## **Service Bulletin**

**No. :** MZ07-090

**Model:** CC4001

**Subject:** The disc tray sometimes will not open.

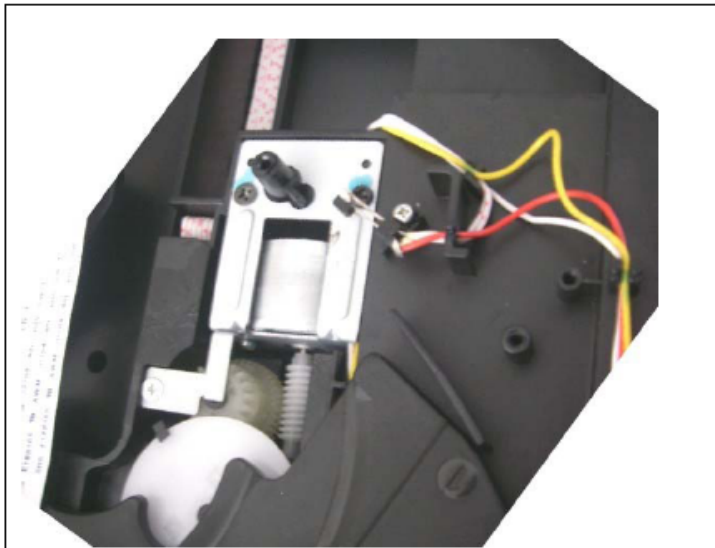
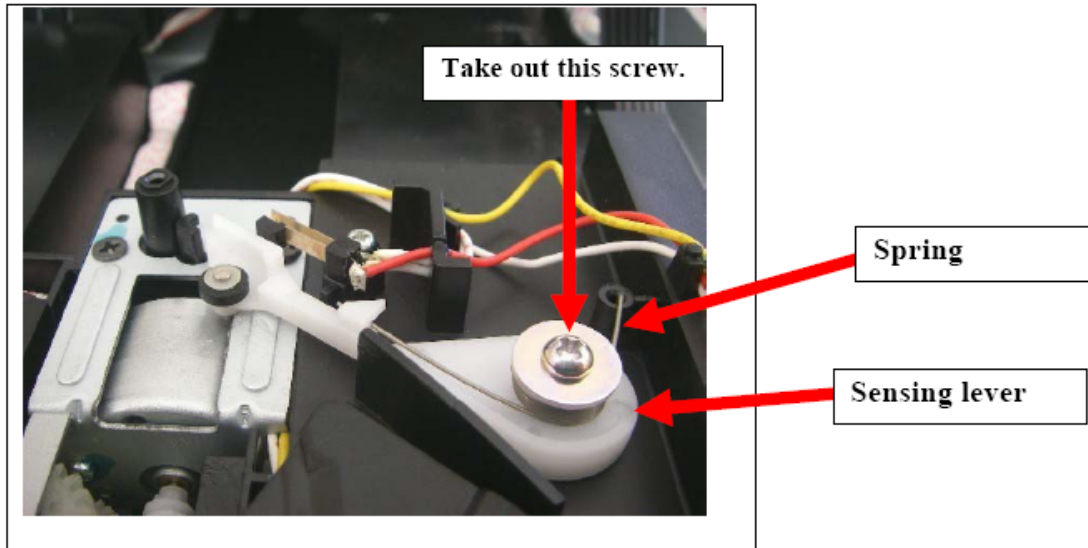
**Symptom:** The roulette (tray) rotation position sensing lever is sometimes caught by a burr that remains on the surface of the motor bracket under the lever.

**Solution:** The burr on the surface of the motor bracket (metal) must be filed off. For the procedure, refer to the following.

- 1) Turn on the power and open the disc tray. If it will not open, use the forced opening lever on the bottom. (For the procedure, refer to the Service Manual on Page 6.)
- 2) Pull the mains cord out of the socket.
- 3) Take out a screw and remove the sensing lever and spring.

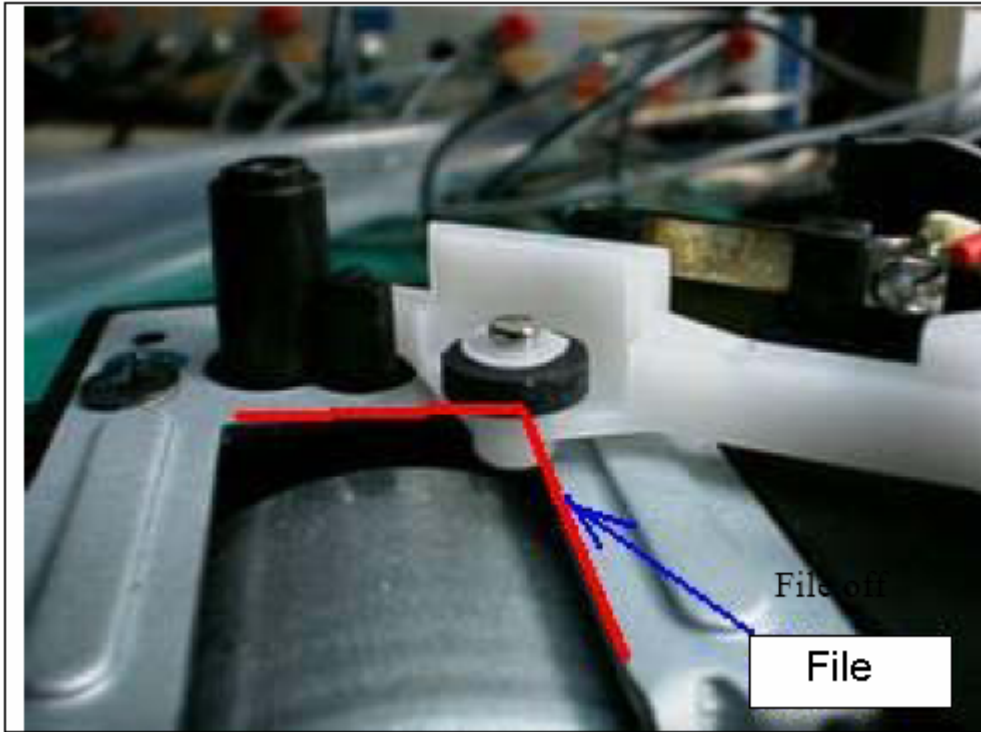
4) File off the burr on the surface of the motor bracket. (See the photo below.) Smooth out the area where the sensing lever moves over.

**Caution:** The motor fixture is greased. When filing, make sure that no metal filings land on the grease or remains in the unit.

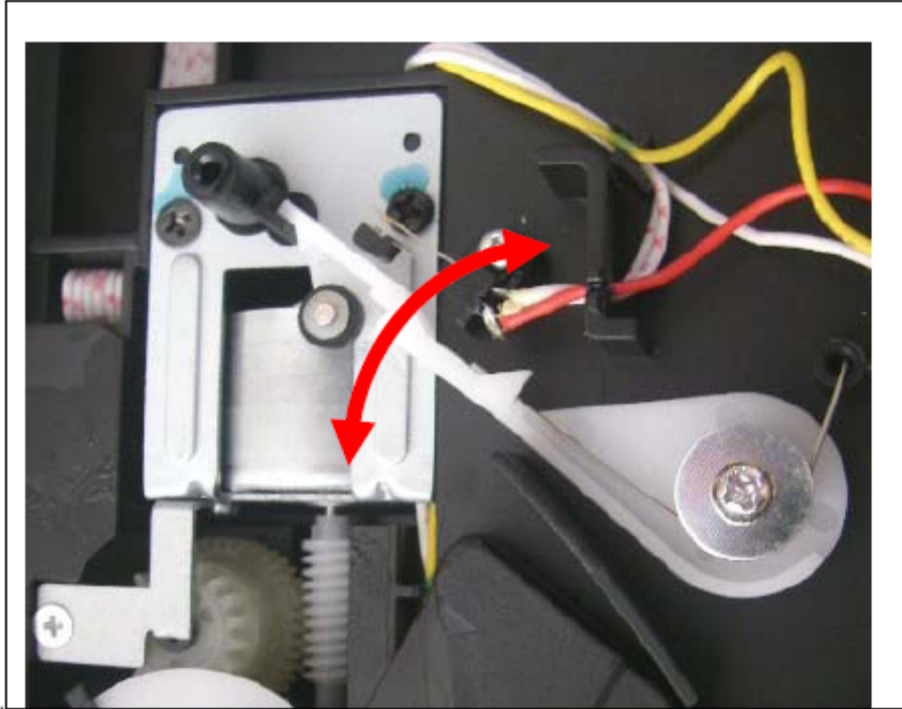
5) Re-attach the sensing lever and spring and screw them down.

6) Manually move the sensing lever and confirm that it moves smoothly.

This is the end of the process. Reassemble the unit and test.
